Safety Evaluation Report

Related to the License Renewal of Prairie Island Nuclear Generating Plant Units 1 and 2

Docket Nos. 50-282 and 50-306

October 2009

Figure 4.3-1

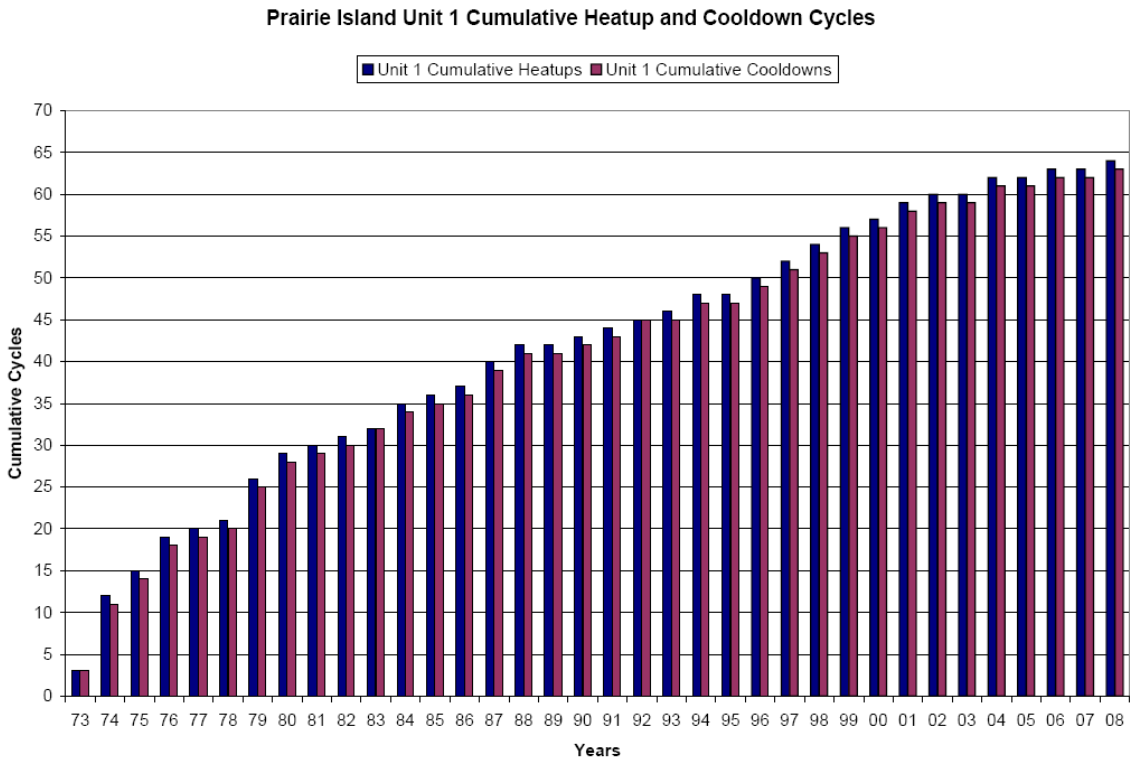
The staff reviewed these histograms and found that the transient occurrence rates (both heatup and cooldown) are quite constant for Unit 1 since 1980 and for Unit 2 since 1983. This means that for the past 25 years, the PINGP (Units 1 and 2) plant operation has been quite steady. The applicant made its cycle projections by doubling the actual number of cycles accrued as of September 30, 2006, using the maximum from either unit. The staff notes that cycle projection can be graphically represented, based on Figure 4.3-1 by drawing a straight line from the intersection of the x and y axes to the 2003 data point, boosted to the cycle value accrued by September 30, 2006, using the maximum from either unit. It is clear from Figures 4.3-1 and 4.3-2, that the slope used by the applicant for making cycle projections is significantly greater than that of the average of the past 25 years. As expected, the slopes of event occurrence (i.e., the rates) during the first few years (5 to 7 years) are higher than the averages for both heatups and cooldowns. This means that the basis of projections that the applicant used is conservative and therefore, the staff found it to be acceptable.

Based on its review, the staff's concern on the transient event monitoring is resolved because the applicant provided the information requested and the information validates the PINGP fatigue management program and the applicant's assumption for the number and severity of transients.
